San Francisco Bay Conservation and Development Commission

TO: Design Review Board Members

**SUBJECT: Ferry Building Alterations Project in the City and County of San Francisco;
Second Pre-Application Review**
(For Design Review Board consideration July 10, 2023)

Figure 4: Proposed Alterations to Entry Portico

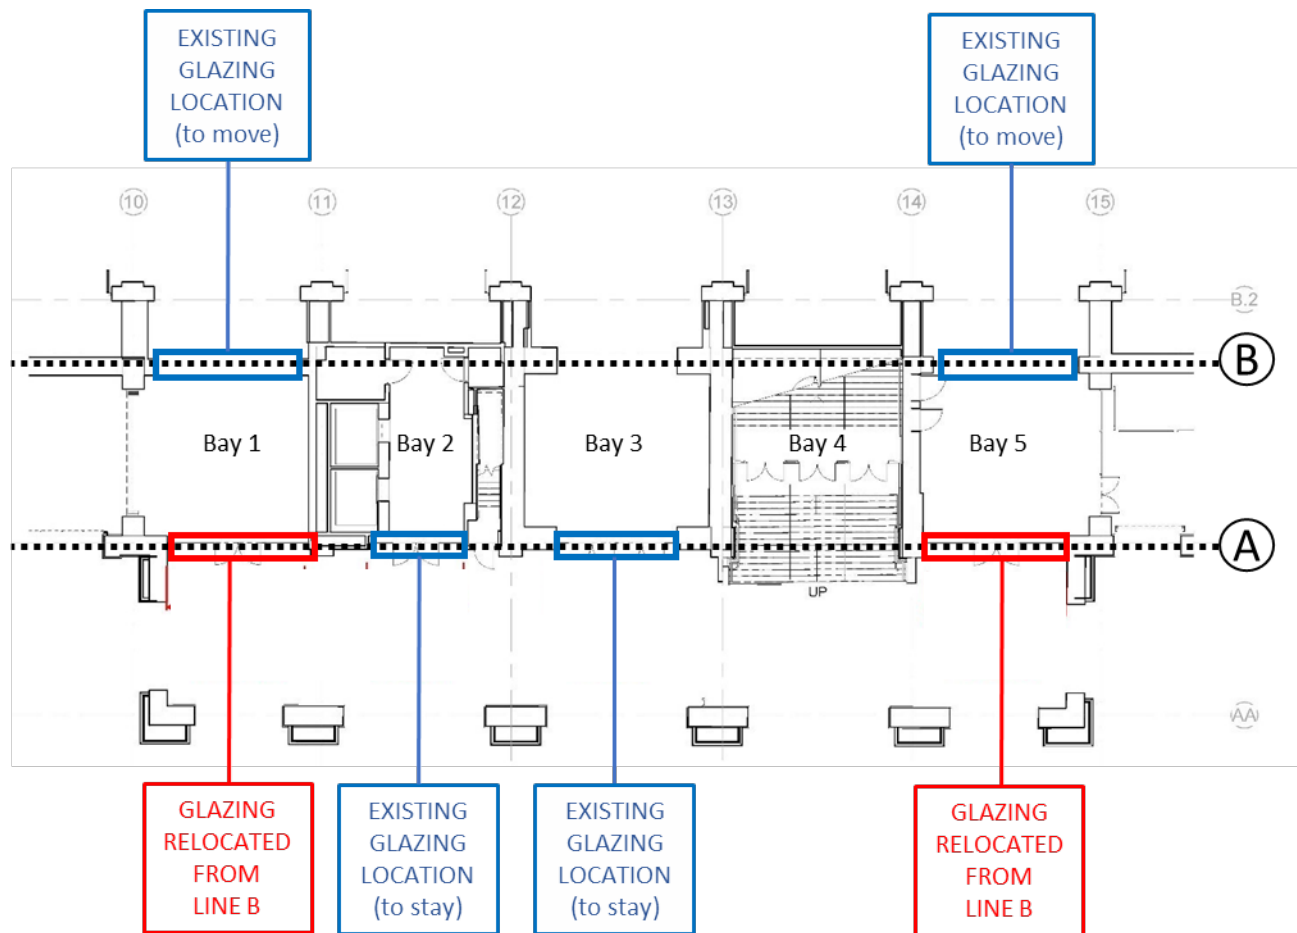
Figure 4 Shows the proposed changes to the portico's glazing. The portico comprises five bays: bay 1 provides access to the northern section of the ground floor marketplace, bay 2 is an elevator vestibule, bay 3 provides access to the central breezeway through the building, bay 4 includes the stairway to the second-floor offices, and bay 5 provides access to the southern section of the marketplace (see Figure 4). Currently, bays 1, 2, 3, and 5 incorporate non-historic glass partitions and glazed doors, but the glazing for bays 1 and 5 are located farther within the structure (at line B in Figure 4) than the glazing for bays 2 and 3 (at line A in Figure 4). The project proposes to relocate the glazing of bays 1 and 5 to be in line with the existing glazing at bays 2 and 3, allowing for more of the portico area to be enclosed.

5. Does the Board have any guidance on the frequency of closure for weather protection related to the activation value for public access? If side panels for weather protection at the arcade canopy areas are proposed in the future, what parameters should be applied to the design and materials to maximize the activation value of the outdoor dining area related to the public access area?

Figure 5: Proposed Alterations to North Arcade

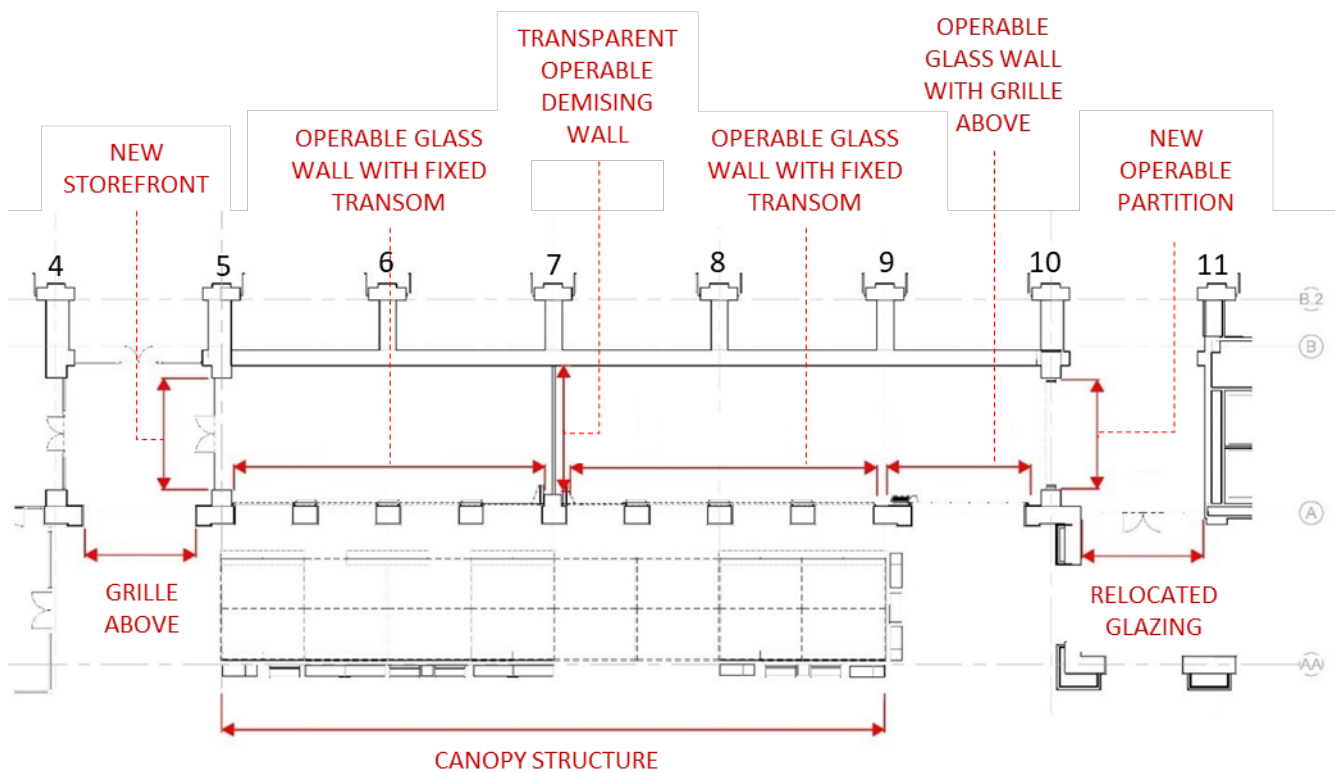
with fixed transoms fabricated with metal framing within the arched openings above would be installed behind the openings to the arcades at their west wall from column line 5 to 9 and 16 to 20 (Figure 5). The larger rectangular opening between column line 9 and 10 will have a similar operable glass wall system that will be full height to the bottom of a fixed grille/louver supplying air intake to the interior space. This operable glass wall system will be hidden behind each column when fully opened and retracted. The glazing is proposed to remain open during temperate days and closed during the evening and during colder weather.

The large rectilinear openings between column lines 4 and 5 at the North Arcade and column lines 20 and 21 at the South Arcade will be left open to the exterior and will contain mechanical vents with decorative grilles at the top portion of their openings to provide required fresh air and exhaust for the spaces within the arcades. These necessary vents with decorative grilles will replace the rolling overhead doors and decorative grilles that were installed as part of the 2003 renovation. A permanently fixed glazed wall with glazed doors will be installed at the north end of the arcade at column line 5 and a glazed operable partition at column line 10 to allow the arcades to be closed and secured.

Figure 6: Bay Front Kitchens Proposal

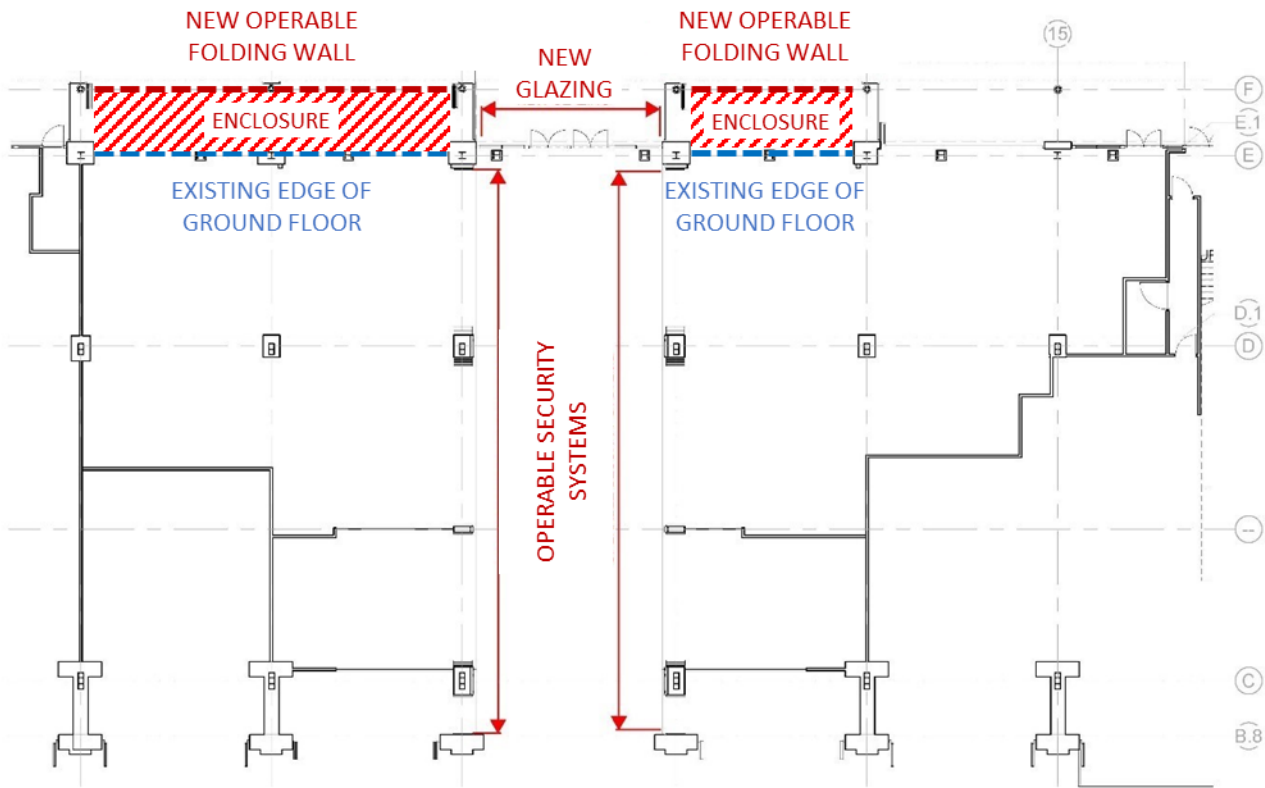
The areas proposed to be enclosed by the new folding wall system are located on Bay fill required to be dedicated as public access by BCDC Permit No. 1997.007.09. That permit required a 32-foot-wide East Promenade along the eastern façade of the building, based on policies in the San Francisco Waterfront Total Design Plan¹ that required continuous public pedestrian access on the east side of the Ferry Building.

When BCDC Permit No. 2000.001.05 for the Ferry Building rehabilitation authorized a cantilevered expansion of the second story over 10 feet of the East Promenade (which at the time had been built to a width of 21 feet), it included a condition requiring that the promenade be expanded by 12 feet such that the total width of the promenade from the building's rehabilitated façade to the Bay edge would be 32 feet. The Findings of the permit explain that the additional 12 feet of width was required to ensure that the promenade would still have nearly the same amount of public access area open to the sky after the extension of the second floor, in accordance with the policies of the Total Design Plan. The permit also includes a condition requiring that a 20-foot-wide corridor along the East Promenade be open to pedestrian flow at all times as well as open to the sky. The condition also allows outdoor dining up to 12 feet bayward of the building's ground floor east façade so long as the area was maintained free of obstructions during rainy weather in order to provide shelter for the public.
